Concerns regarding the clock model used in 60802 time synchronization simulations

**December 21, 2020
IEC/IEEE 60802 Joint Project Call**

Jordon Woods, Analog Devices

Figure 3. Typical PWA Thermal Cycling Profile

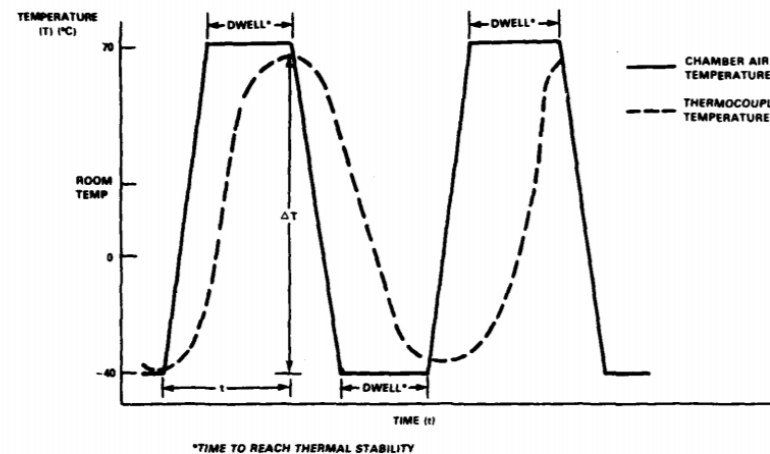
- Develop a frequency stability model for the local clock that depends on temperature
 - Calculate f based upon the enclosed formula or a suitable alternative.
 - Randomly assign f_0 based upon frequency tolerance rather than frequency stability.
 - Choose representative values for T_0 (25 C), and TC (0.050 ppm/°C²)
 - Select a representative thermal profile/cycle
 - -40 to +85 C; 25 C/min w/ 5-minute soak yields a period of 20 minutes
